**NZ 223/05 SOUTH PACIFIC – Fiji Islands – Vita Levu South-South-Westwards – Discoloured Water.**

**Chart NZ 14602 (INT 602) [198/05]**

LAST CORRECTION	NZ NTM No.	CHART No.
NZ 198/05	NZ 223/05	NZ 14602 (INT 602)

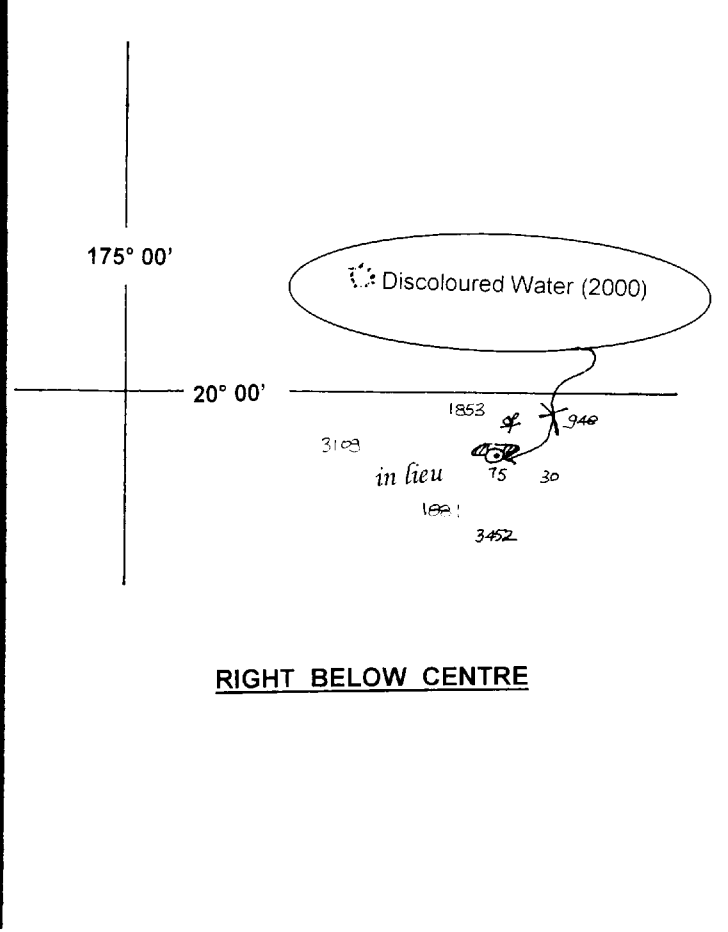
Insert  *Discoloured Water (2000)* (a) 20° 14'S., 176° 41'E.  
Delete depth 3244 close N. of (a)

LAST CORRECTION	NZ NTM No.	CHART No.
NZ 214/05	NZ 223/05	NZ 14604 (INT 604)

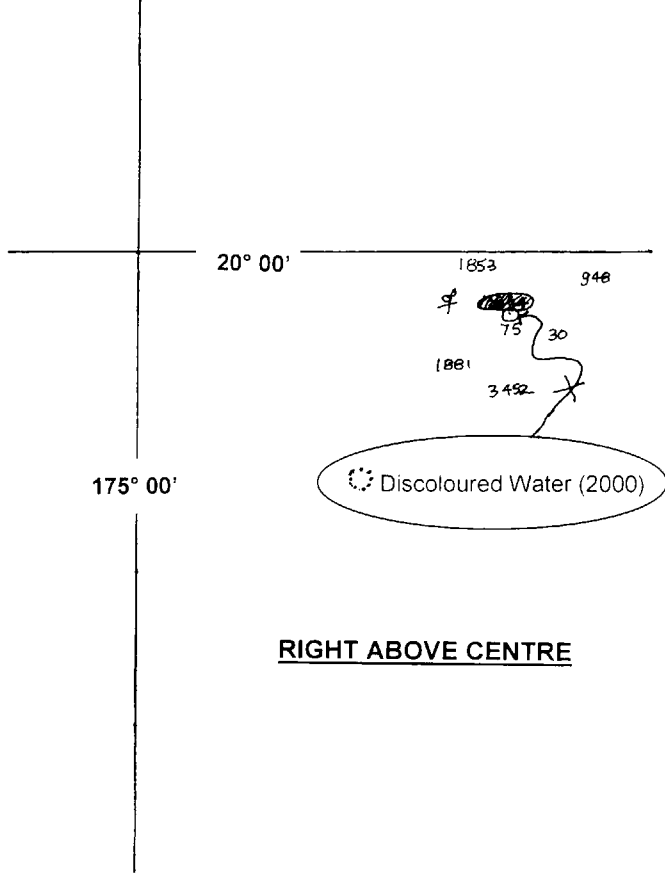
Substitute  *Discoloured Water (2000)*, for depth 3244 20° 14'S., 176° 41'E.

LAST CORRECTION	NZ NTM No.	CHART No.
NZ 28/05	NZ 223/05	NZ 14605 (INT 605)

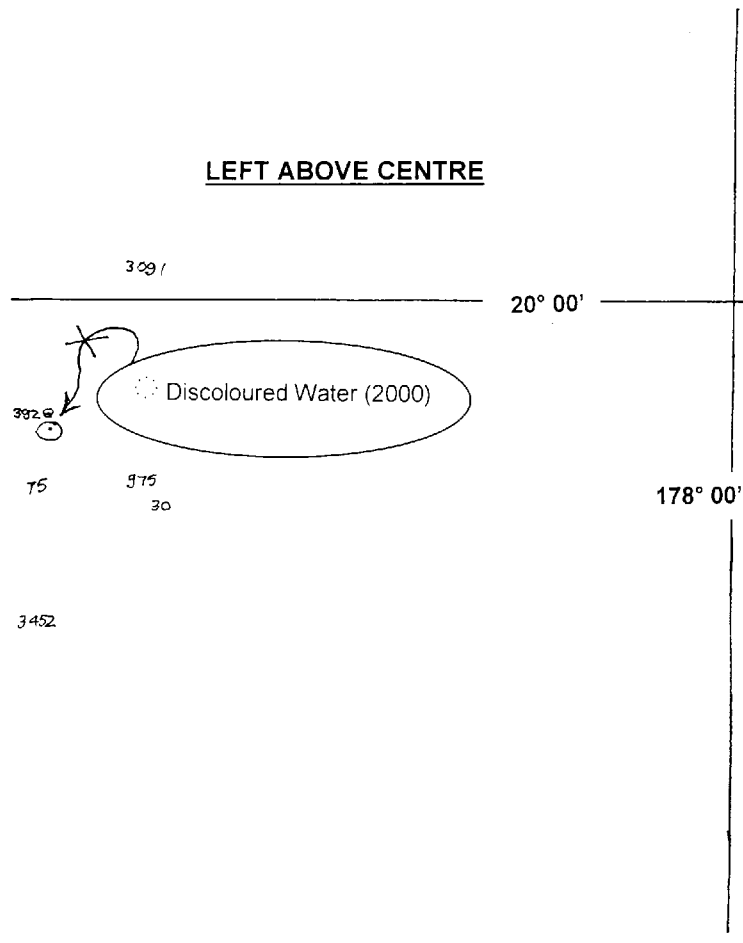
Substitute  *Discoloured Water (2000)*, for depth 3244 20° 14'S., 176° 41'E.

LAST CORRECTION	NZ NTM No.	CHART No.
NZ 41/04	NZ 223/05	NZ 14638 (INT 638)

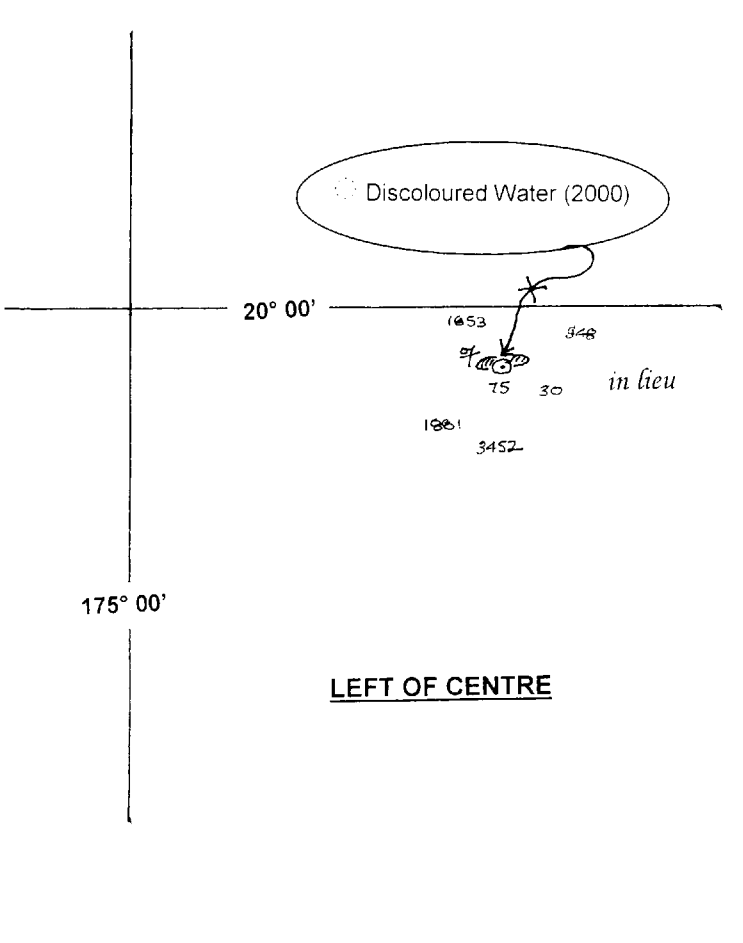
Insert  *Discoloured Water (2000)* 20° 13'.7S., 176° 40'.5E.
